**Economic Commission for Europe****Inland Transport Committee****World Forum for Harmonization of Vehicle Regulations****Working Party on Lighting and Light-Signalling****Eighty-fourth session**

**Simplification of lighting and light-signalling UN Regulations:****Simplification of UN Regulations Nos. 48, 53, 74 and 86****Revised proposal for a new [0x] series of amendments to UN Regulation No. 48****Submitted by the Informal Working Group on Simplification of Lighting and Light-Signalling Regulations\***

The above limits and the initial aiming values are summarized in the diagram below.

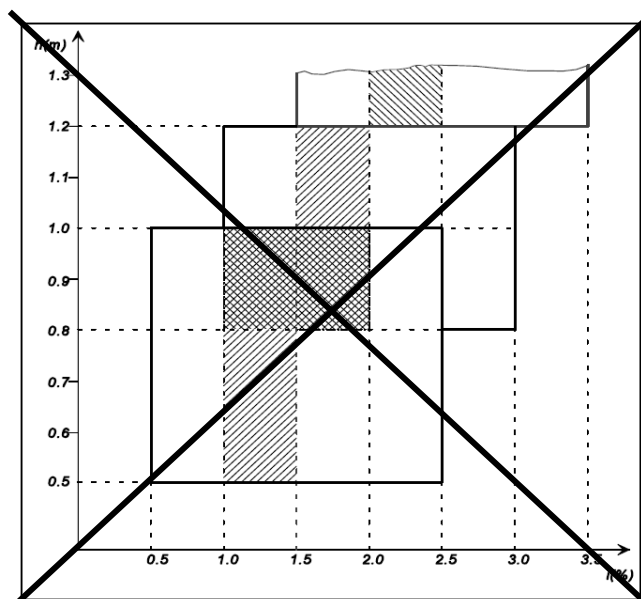
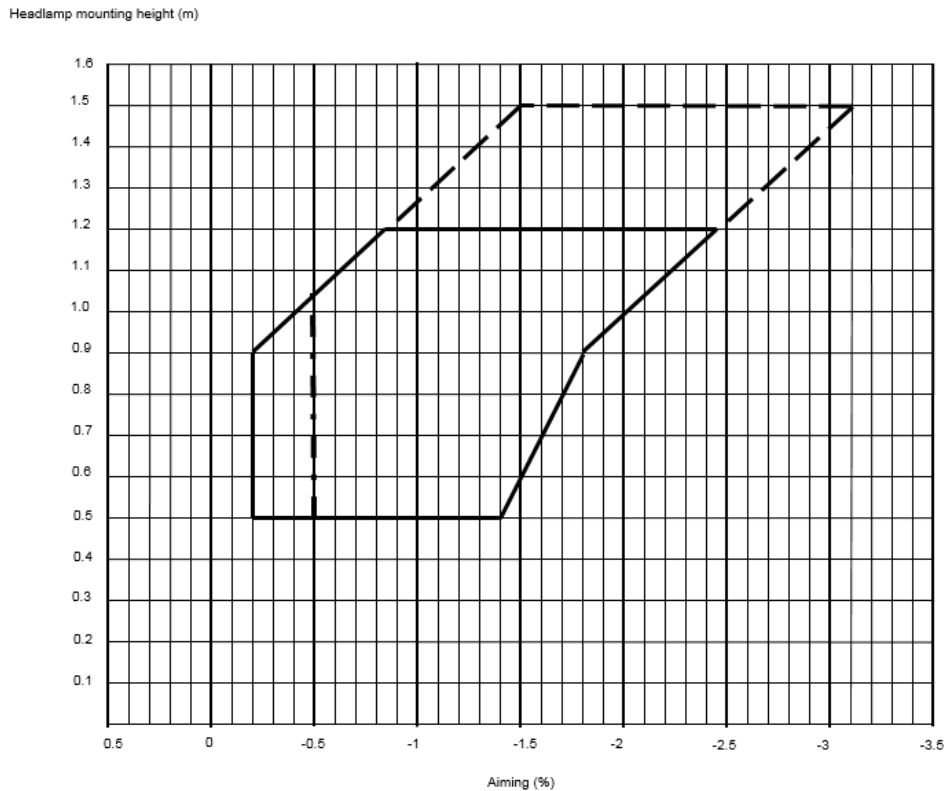
Depending on the mounting height in meters (h) of the lower edge of the apparent surface in the direction of the reference axis of the **passing-beam** (dipped-beam) headlamp, measured on the unladen vehicles, the vertical inclination of the cut-off of the **passing-beam** (dipped-beam), **starting from the initial downward inclination value set by the vehicle manufacturer as prescribed in paragraph 6.2.6.1.1.**, shall under all the static conditions of Annex 5, remain between the following limits and the initial aiming shall have the following values, **under all the static loading conditions of Annex 5:**

Mounting height $h$ [m]	Upper inclination limit [per cent]	Lower inclination limit [per cent]
$0.5 \leq h \leq 0.9$	-0.20	-1.40 to -1.80*
$0.9 < h \leq 1.2$	-0.20 to -0.85*	-1.80 to -2.45*
$1.2 < h \leq 1.5^{**}$	-0.85 to -1.50*	-2.45 to -3.10*

13. Paragraph 6.2.6.1.2. describes the new requirements for the vertical inclination limits of the cut-off, the provisions of which have been reorganised to improve readability. The vertical inclination values according to the installation height are presented in a table. A new diagram has been inserted providing an illustration of the requirements (aiming in per cent on the horizontal axis and headlamp mounting height in meters on the vertical axis).

14. Explanations of the lines in the diagram are given below.

15. The vertical line on the left was initially defined at 0 per cent and derived from the GTB study based on the 'Klettwitz study' (informal document GRE-71-32). However, some Contracting Parties were reluctant to have the horizontal cut-off with no downward inclination. At its seventy-eighth session, GRE experts decided to keep the previous vertical limit of - 0.2 per cent.

16. The inclined line on the left (starting from 0.9 m\* in height), results from a mathematical calculation based on the position of the oncoming driver's eyes (at 0.94 m high) for headlamps up to a height of 1.2 m, measured at a distance of 25 m and with an initial aim of 1 per cent down. Using this calculation, it is possible to increase the inclination proportionally to the installation height and still guarantee that glare remains under control; the cut-off line will always stay under 0.94 m at 25 m distance (informal document VGL-10-03, sheet 13).

17. In addition, the line on the left side of the diagram was extended from a height of 1.2 m to 1.5 m in spite of the fact that, during the Klettwitz tests, no vehicles of categories M<sub>2</sub>/M<sub>3</sub>/N<sub>2</sub>/N<sub>3</sub> were tested. This is the reason the lines above a height of 1.2 m are shown as dotted lines.

18. To cover all possible cases of a same type of vehicle (aiming tolerances / chassis deviation / cut-off-line stability / tyre deviation / full or empty tank / levelling device), a range of 1.6 per cent was agreed (see a survey of the International Organization of Motor Vehicle Manufacturers (OICA), informal document VGL-10-10) and used to define the right hand limit and the point (-1.8 / 0.9), based on line defined in item 16.

19. Starting from 0.9 m high, the range of 1.6 per cent is applied to define the line on the right side of the diagram and up to 1.5m.
20. On the right side, under 0.9 m high, there was a compromise to reduce the range progressively to 1.4 per cent at a height of 0.5 m (ECE/TRANS/WP.29/GRE/81, para. 10 and Annex II).

21. The vertical dotted line at -0.5 per cent is already explained in item 10 to address the PTI concerns.
22. The paragraph 6.2.6.2.2. (containing the requirements for manual levelling devices) is proposed to be amended to allow manual levelling only for off-road vehicles (M<sub>2</sub>G, M<sub>3</sub>G, N<sub>2</sub>G, N<sub>3</sub>G). On and off-road vehicles used for special purposes are usually equipped with a steel suspension at the front and rear axles. Placement of the sensor in the suitable location on the vehicle is critical for the operation of the system, this position is difficult to protect against mud and spray water (see the figure below). For vehicles operating in a very harsh environment adding sensors for automatic levelling systems is a reliability risk. Finding usable positions for the sensors with the different vehicle configurations is not always possible.

**“The controls for the headlamp-levelling devices referred to in paragraph 6.2.6.2.2. of this UN Regulation**

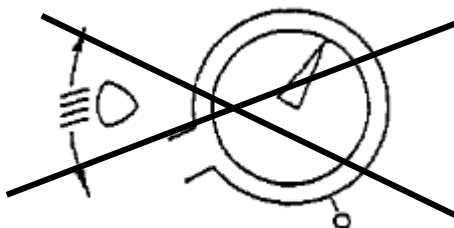
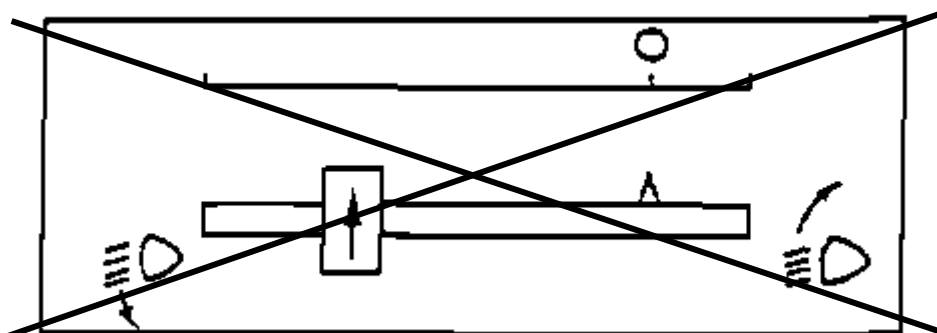
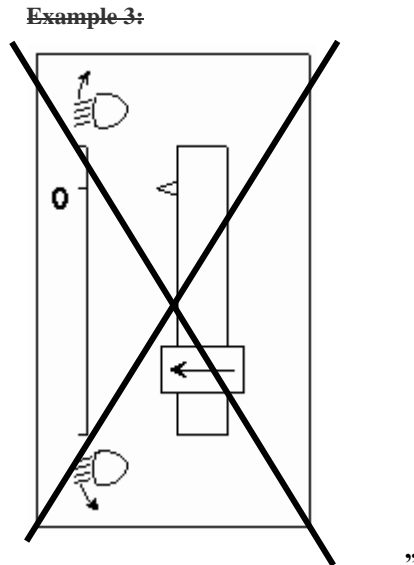
1. Specifications
  - 1.1. ~~Downward~~Inclination of the dipped-beam shall in all cases be produced by a **simple control, the operation of which is clearly described in the owner’s handbook. in one of the following ways:**
    - (a) ~~by moving a control downwards or to the left;~~
    - (b) ~~by rotating a control in a counter clockwise direction;~~
    - (c) ~~by depressing a button (push pull control).~~

A rotary control that is installed edge on, or with only the edge visible, should follow the operating principles of control of types (a) or (c).
  - 1.1.1. This control shall carry symbol(s) indicating clearly the movements corresponding to the downward and upward inclination of the dipped-beam.
  - 1.2. The "0" position corresponds to the initial inclination according to paragraph 6.2.6.1.1. of this Regulation.
  - 1.3. The marks used on control shall be explained in the owner's handbook.
  - 1.4. Only the following symbols may be used to identify the controls:

- ‘Downward’ should be deleted. In the old text it is referring to the direction of the control device. For trucks dipped-beams are adjusted both upwards and downwards, due to different loading characteristics of different vehicle configurations.
- In order for the requirements to be technology neutral, the prescriptions of control methods (downwards, rotary, push-pull) have been deleted.
- The requirement in para. 1.3., referring to the owner’s handbook, has been moved into the main regulatory text (see paragraph 6.2.6.2.2.[5].) and therefore can be deleted.
- The requirement in para. 1.4., specifying the symbols that can be used, has been deleted as these are already prescribed in UN Regulation No. 121.
- Examples of controls 1, 2 and 3 have been deleted, as the illustrations are considered outdated.
